# Historic Landmark Commission

## Memorandum

Date: February 27, 2013

Re: Stevig Residence Follow Up (PLNHLC2012-00624 – New Construction and  
PLNHLC2012-00696 – Special Exception for Height)

option 1

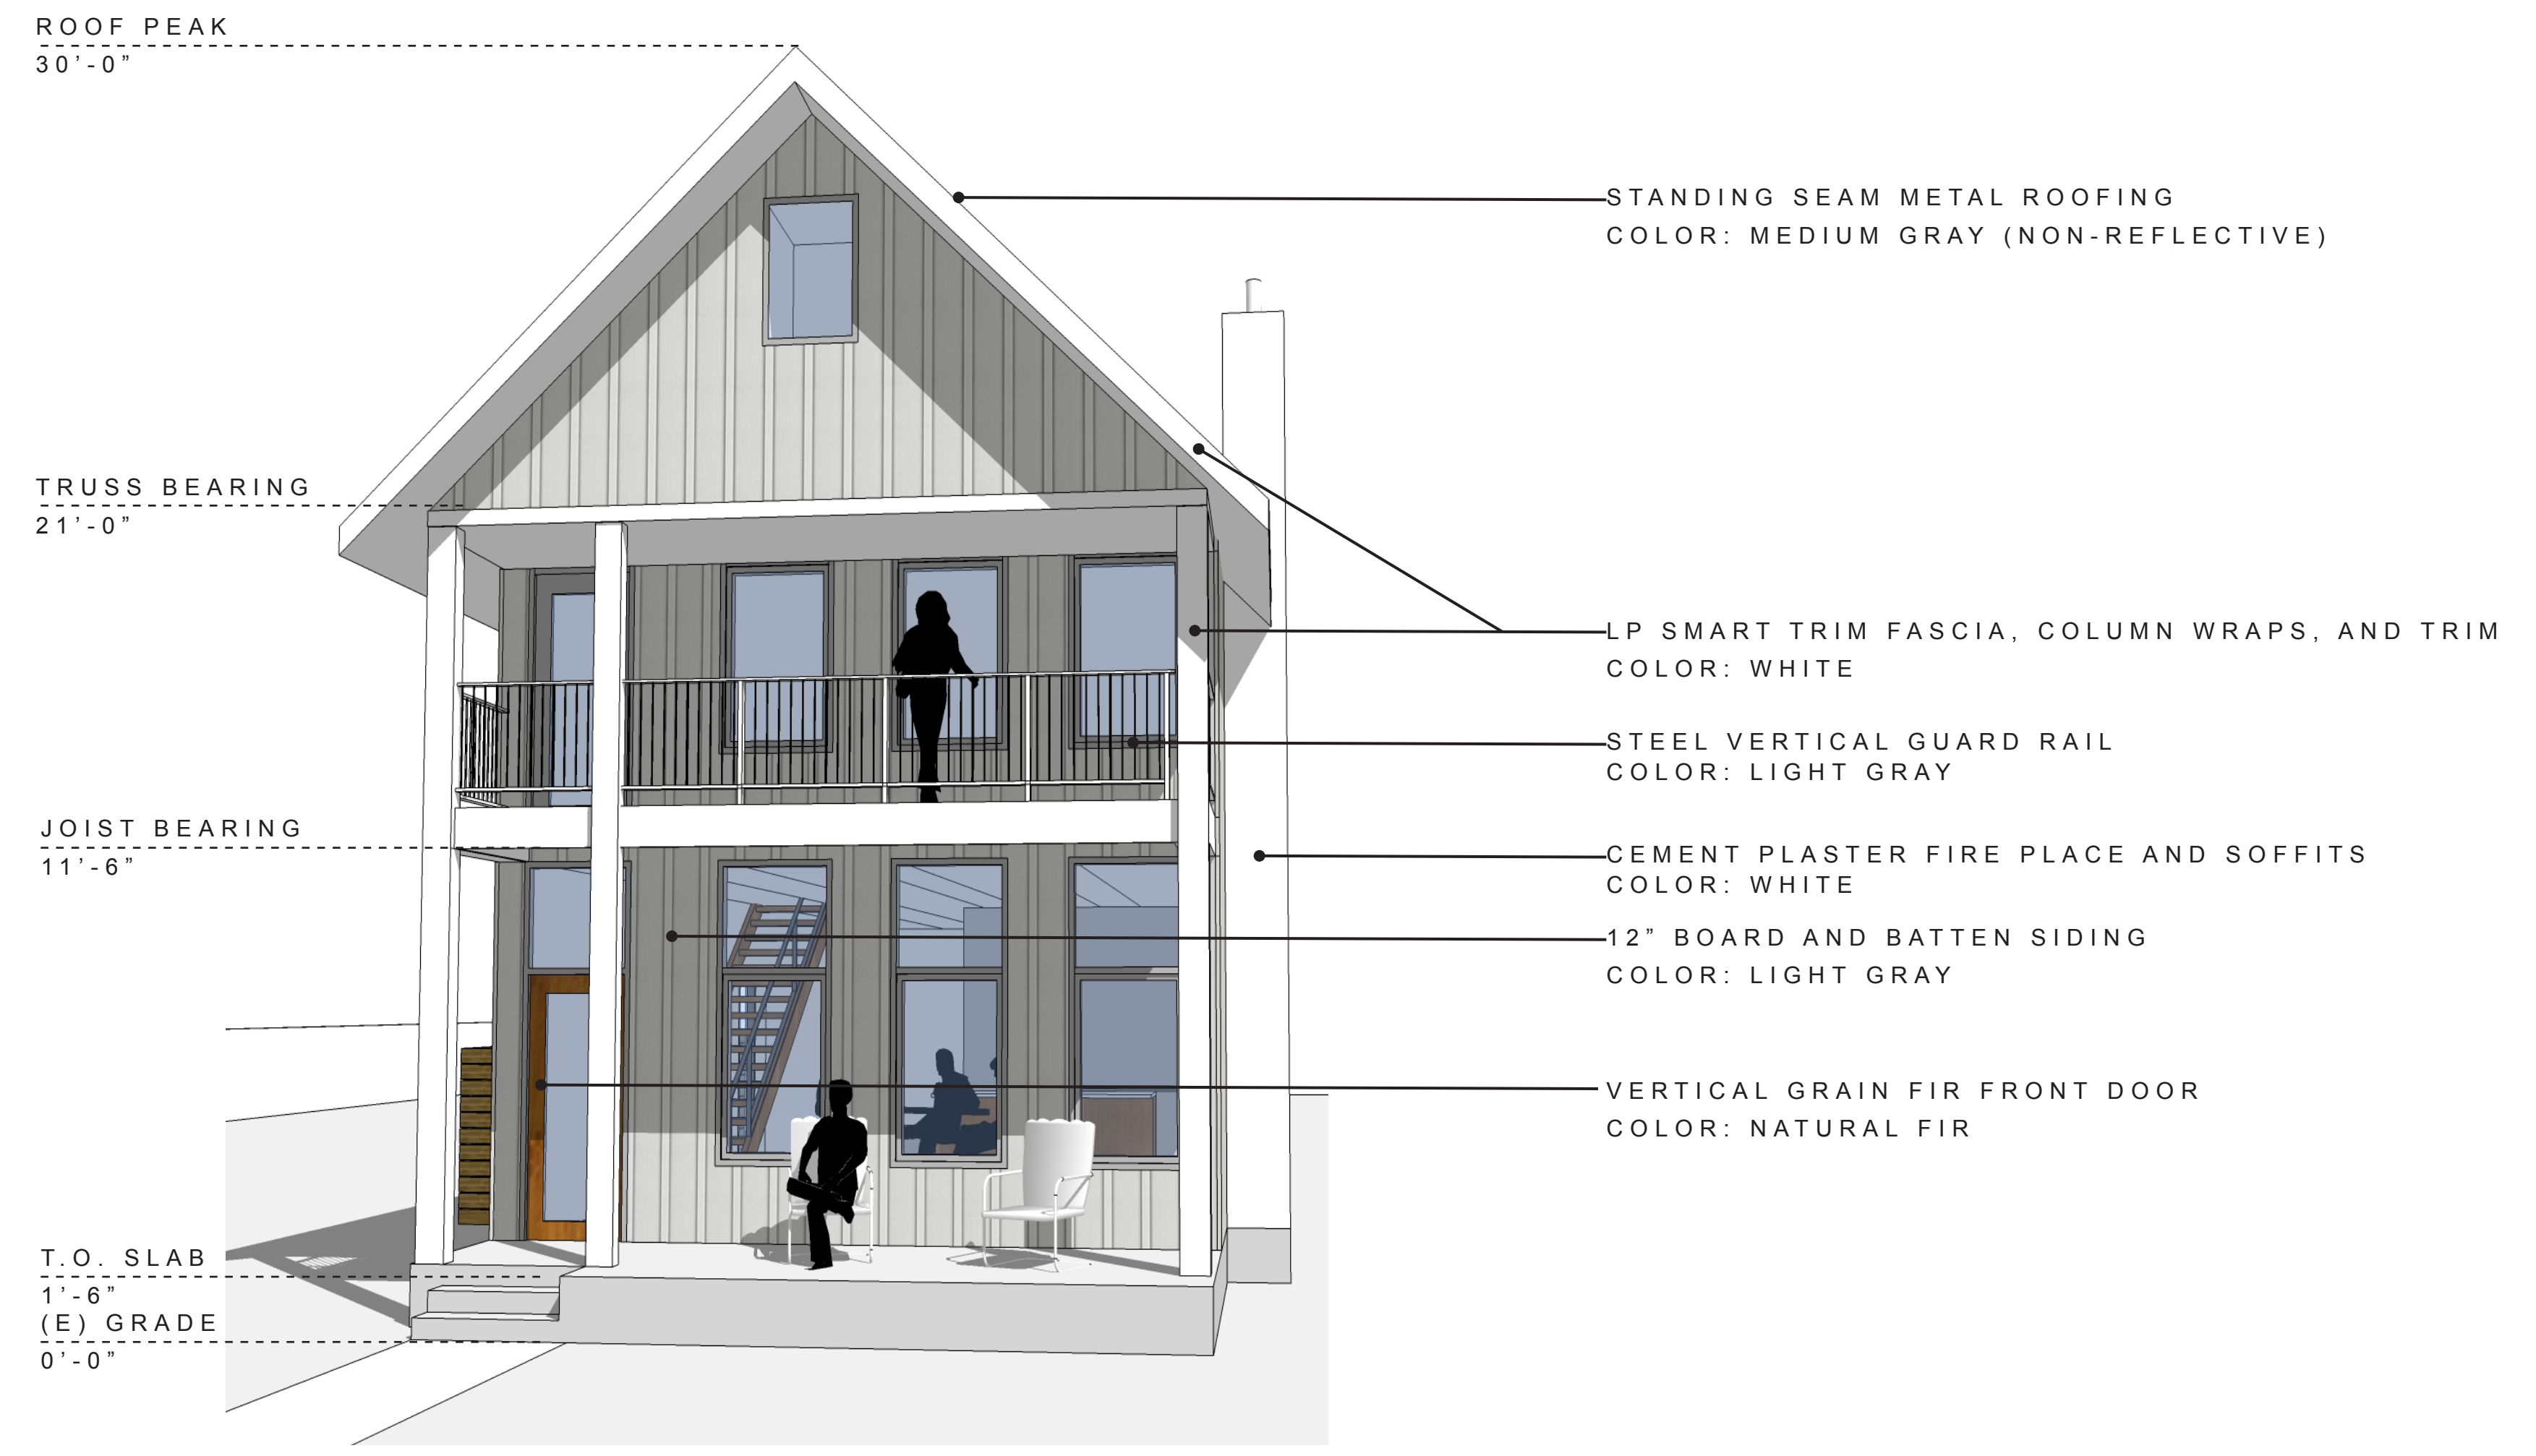
The proposed structure is 28' tall and includes a standing seam metal roof, an open second story balcony with horizontal railing, an open ground floor porch with no railing and the homes siding consists of horizontal metal and plaster. The balcony windows and doors are massed together and the west end of the balcony is enclosed in an attempt to buffer the neighboring noise and artificial lighting.

VIEW LOOKING NORTH-EAST

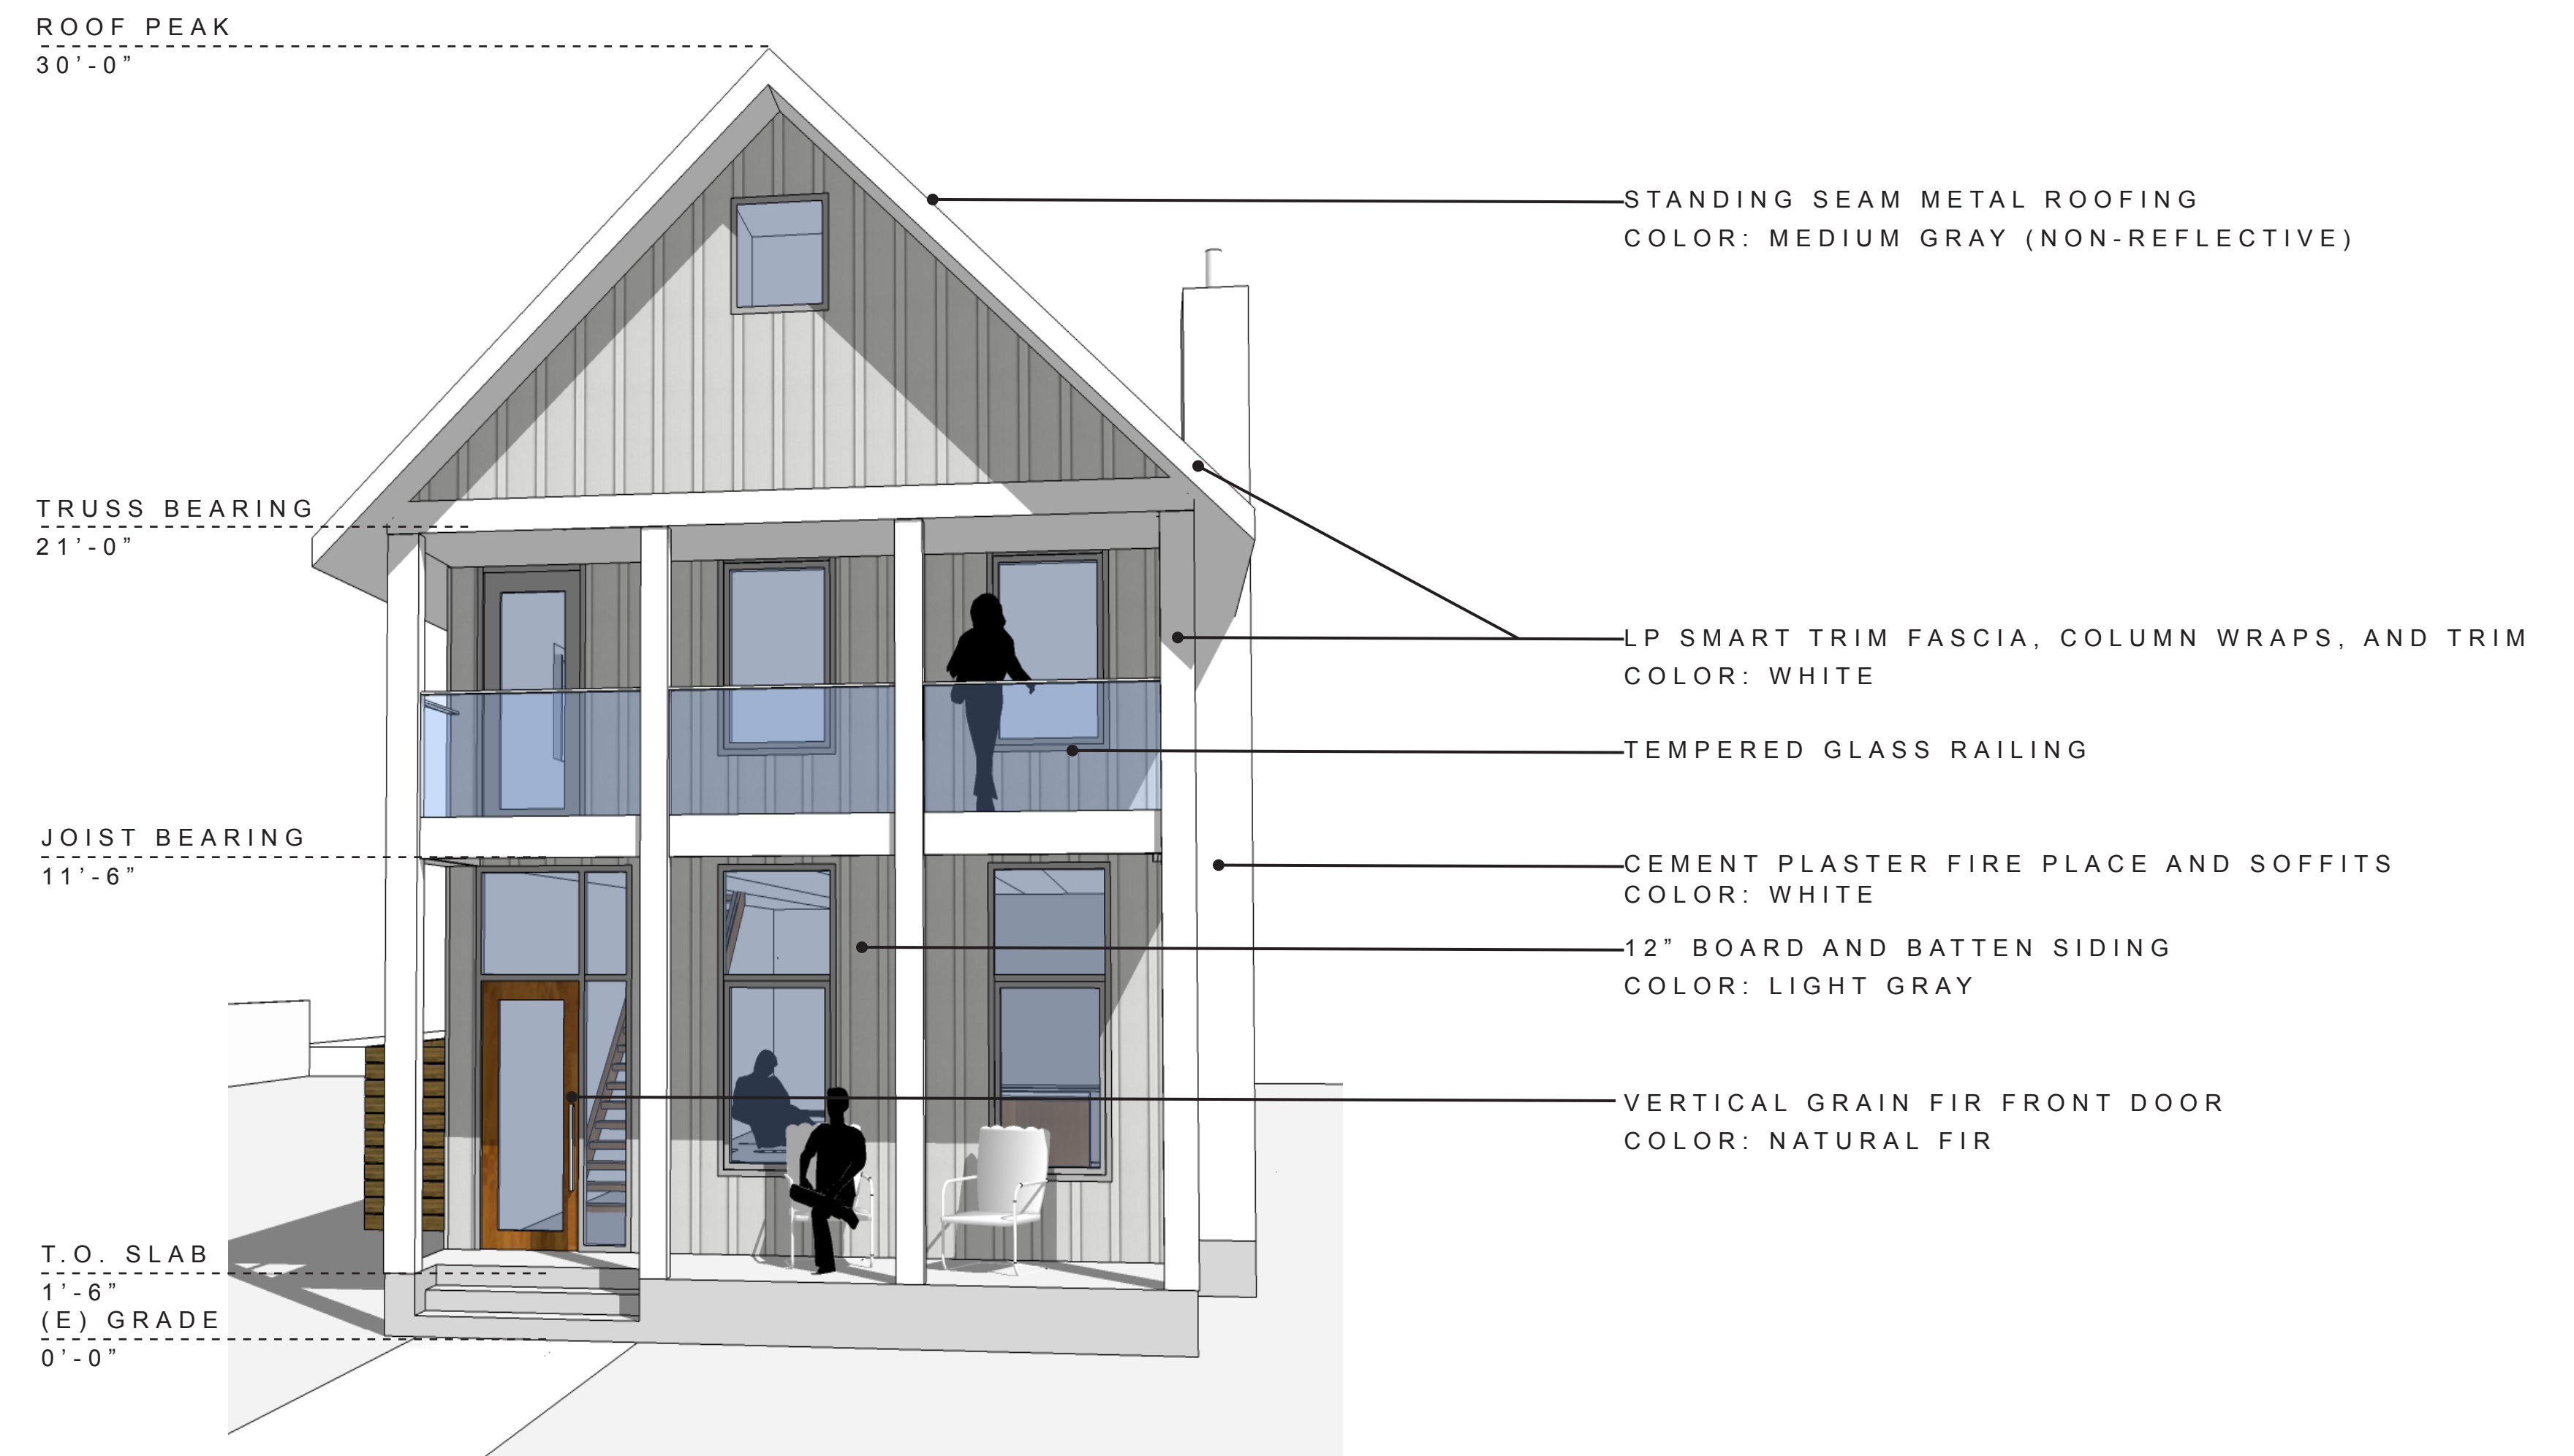
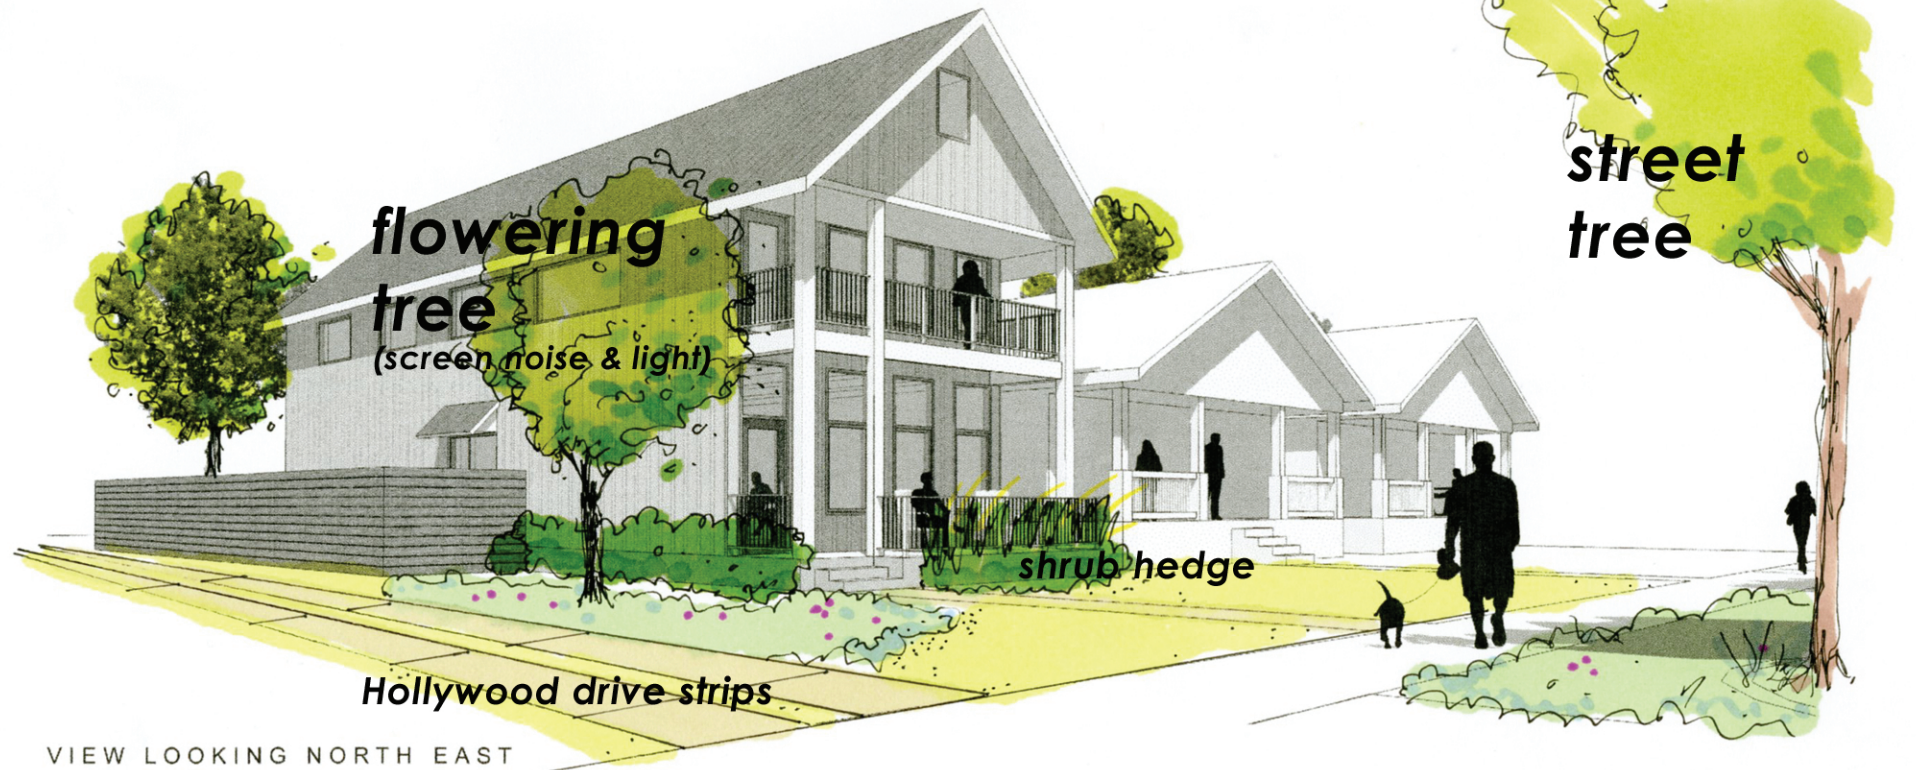
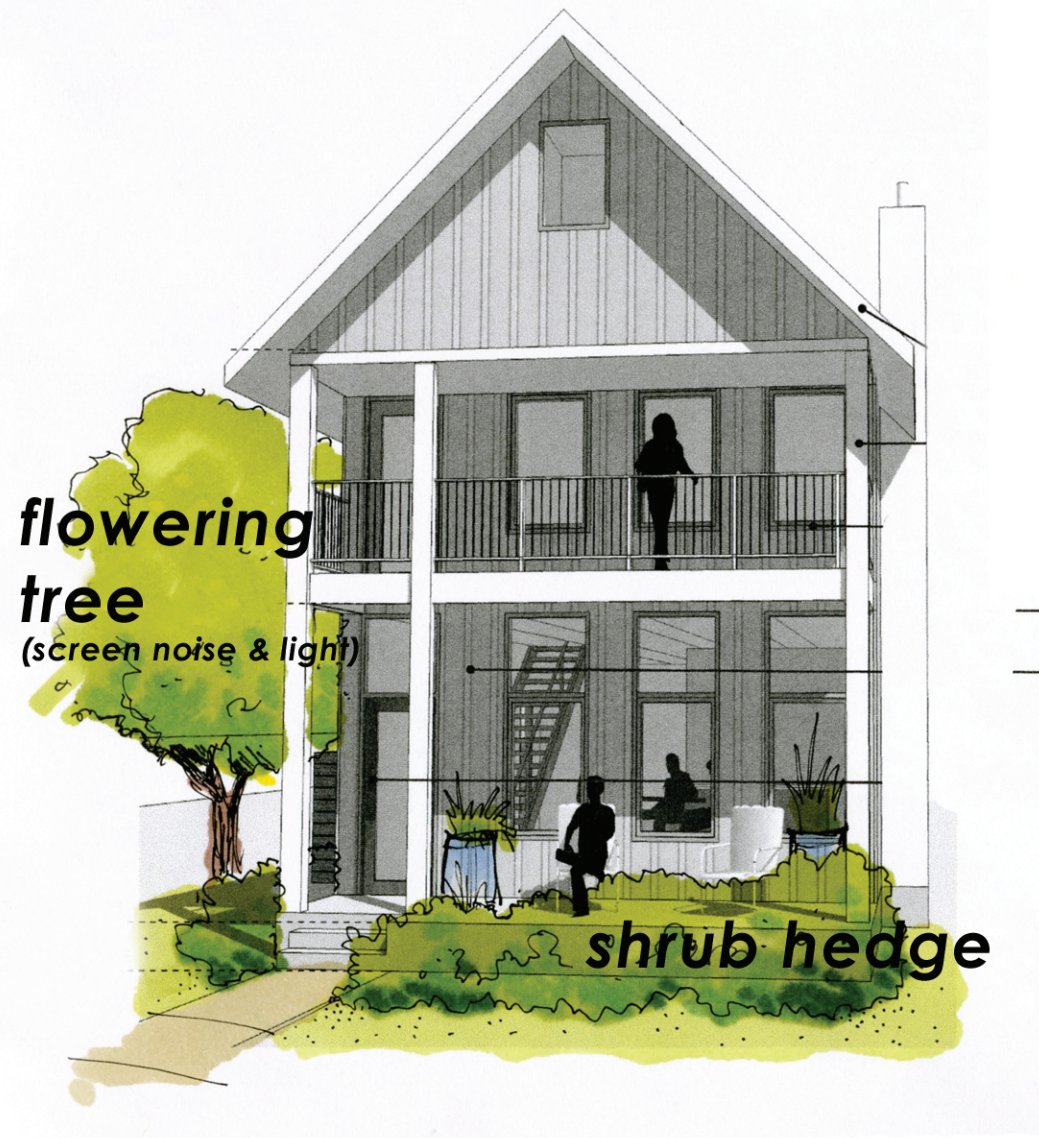
The proposed structure is 30' tall and includes a standing seam metal roof, a second story covered balcony, vertical railing, a ground level porch (shown with and without railing) and the homes siding is traditional vertical Board and Batten. The front door is framed with two (2) columns. There are evenly spaced doors and windows on the first and second levels. The west end of the second story balcony has been open up and a flowering tree has been strategically placed to screen noise, artificial light and the harsh west sun. A shrub hedge is placed along the front porch; providing a natural and pleasant porch enclosure.

The proposed structure is 30' tall and includes a standing seam metal roof, a second story covered balcony, clear glass railing, a ground level porch with no railing and Board and Batten siding. There are a total of four (4) columns placed evenly across the front of the home, reflecting the rhythm found throughout Historic Marmalade. There are evenly placed windows and door on the first and second level. The west end of the second story balcony has been open up and a flowering tree has been strategically placed to screen noise, artificial light and the harsh west sun. A shrub hedge is placed along the front porch; providing a natural and pleasant porch enclosure.
